Value Engineering Study
***US 127 FROM KY 90 TO
JAMESTOWN BYPASS***
CLINTON & RUSSELL COUNTY, KENTUCKY

***ITEM NUMBER 8-108.00 & 8-115.10
VE STUDY NUMBER 201102***

Study Date: February 28 -
March 4, 2011

Final Report

VALUE ENGINEERING RECOMMENDATION # VE-15
SKETCH OF RECOMMENDED DESIGN

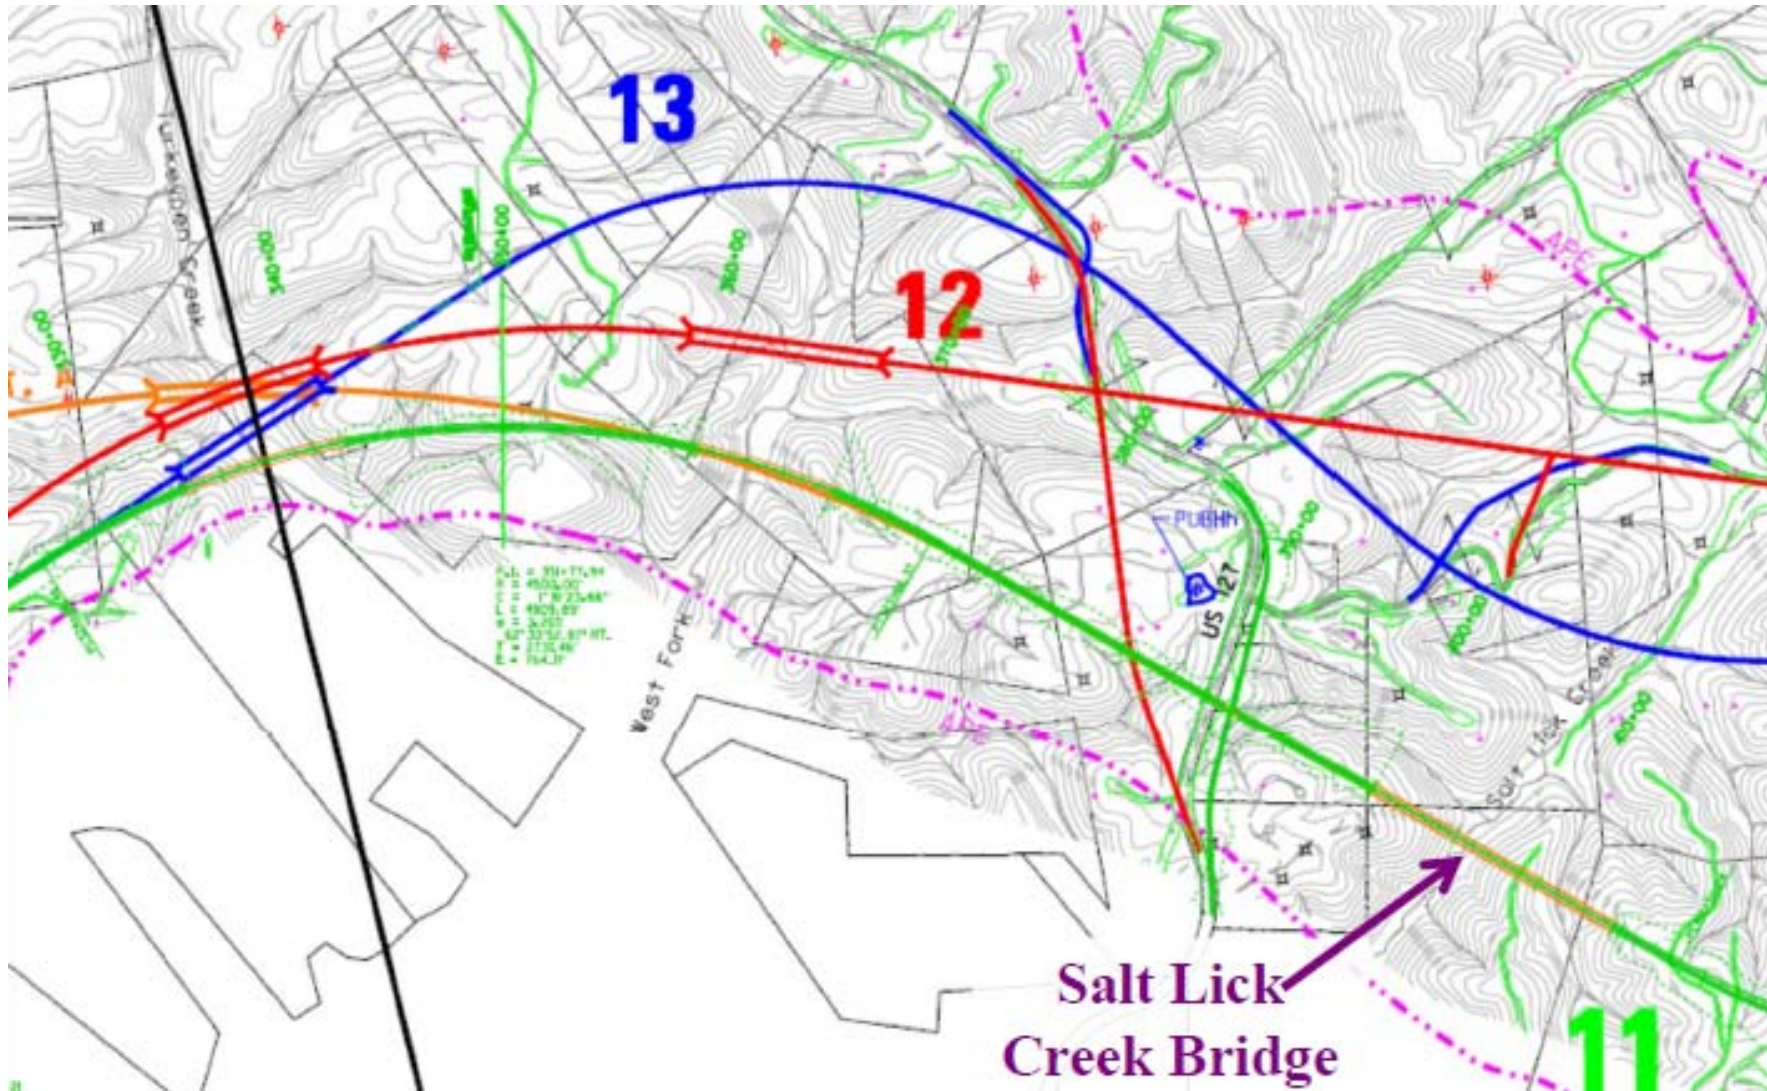
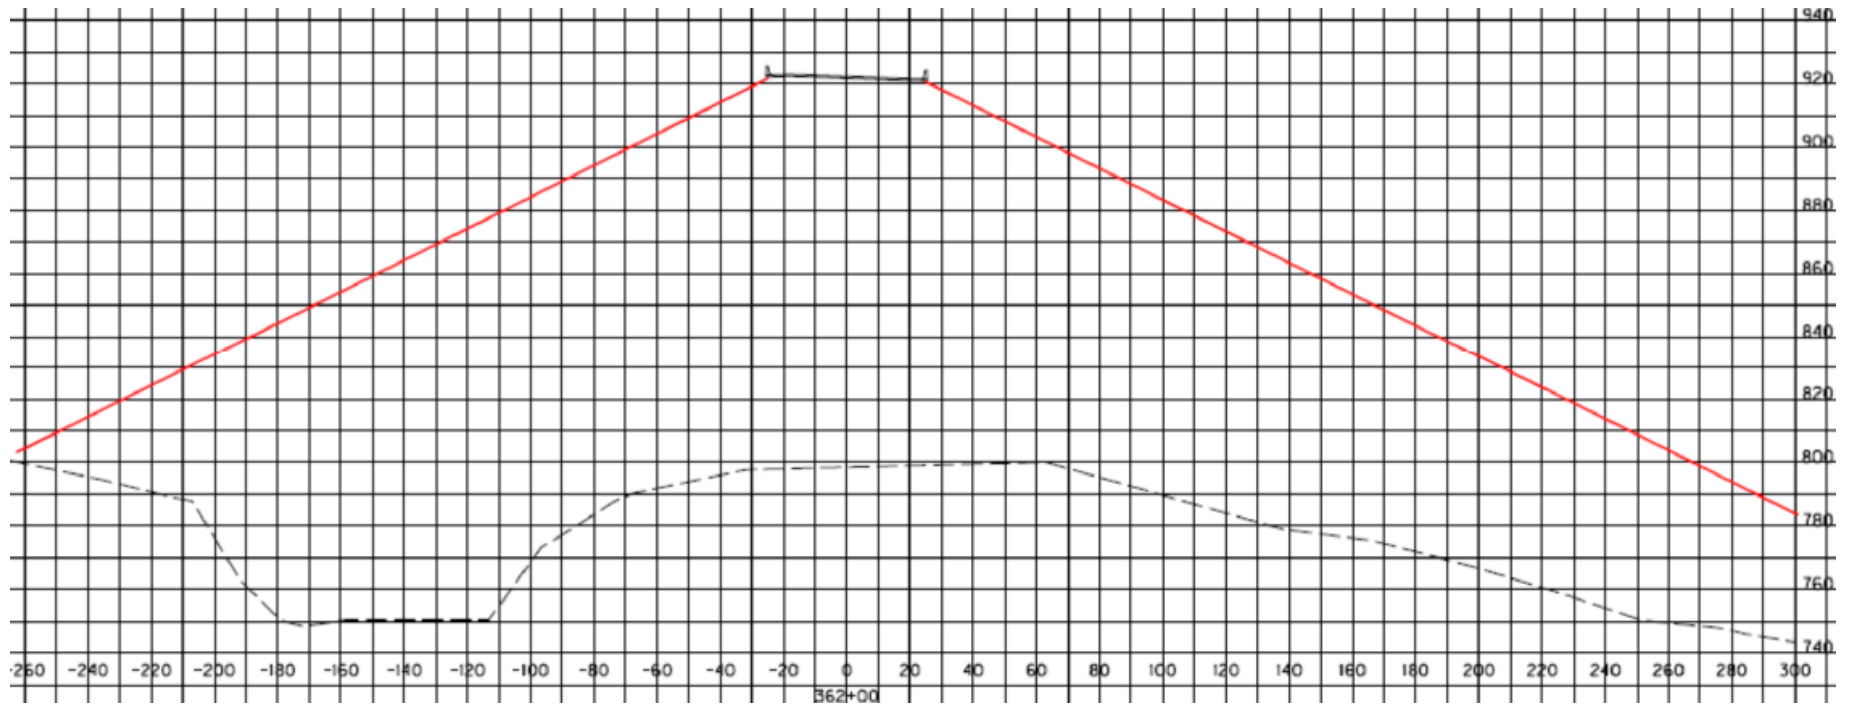
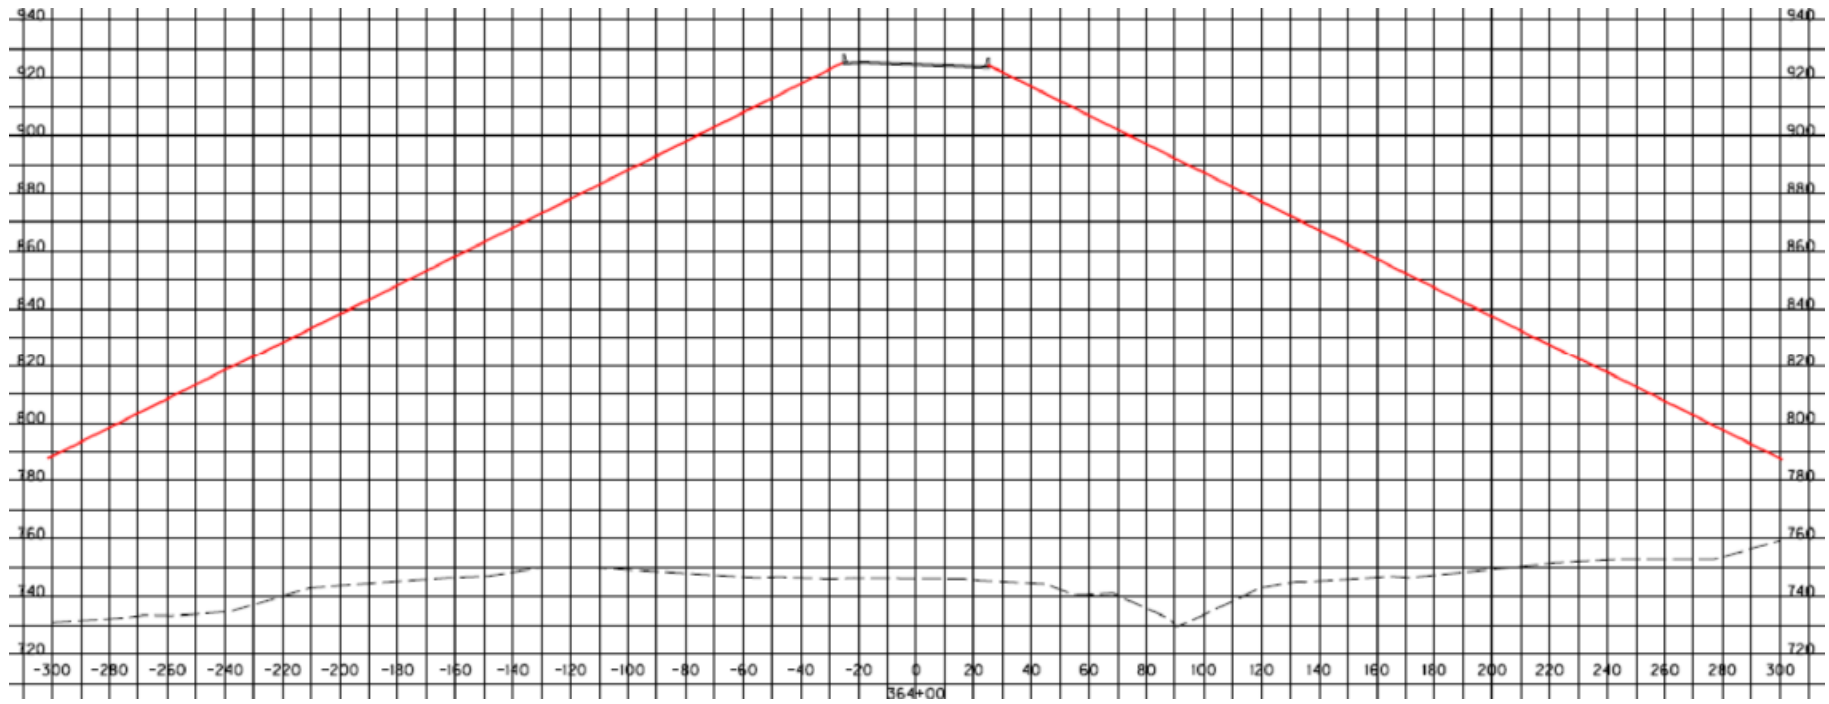
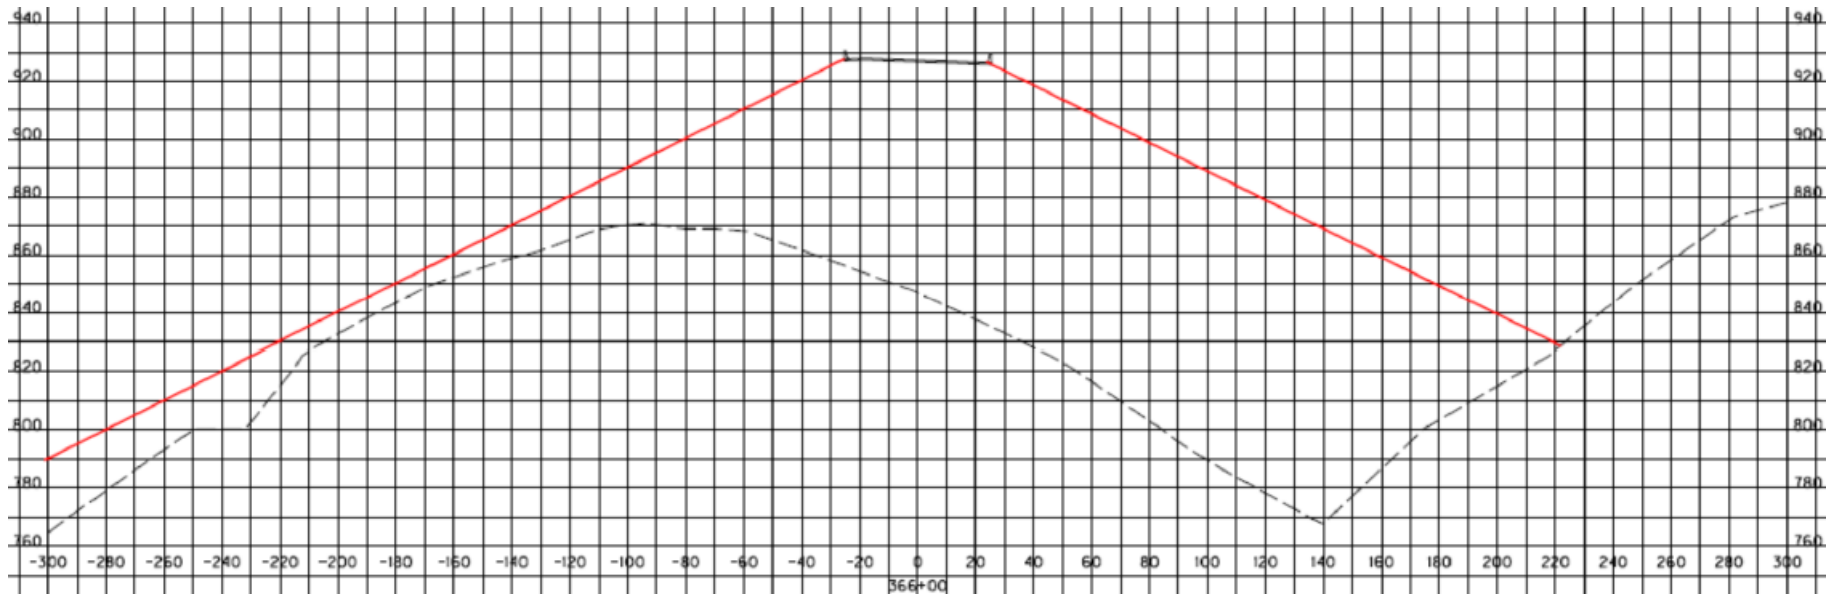
The original design specifies a bridge spanning Salt Lick Creek and the associated valley. Based on preliminary recommendations the estimated bridge length is 1,444 feet with a 51 foot bridge width. The valley at this location is approximately 225 feet below the profile grade for US 127. Based on the required pier height for this structure the VE team revised the project team’s square foot costs for the bridge to \$300 per square foot from \$105 per square foot to reflect the increased span lengths and complexity of constructing tall piers.

The revised initial construction costs are significantly reduced by eliminating the proposed structure in lieu of a culvert structure and embankment. A secondary benefit would be the elimination of future deck overlays/replacement, painting, and other bridge maintenance items. This VE proposal assumes a fill cost of \$6 per square foot. While not studied as part of this recommendation, adjusting the profile to reduce the depth of fills and better balance the overall cut fill for the project would increase the benefit of this VE recommendation.
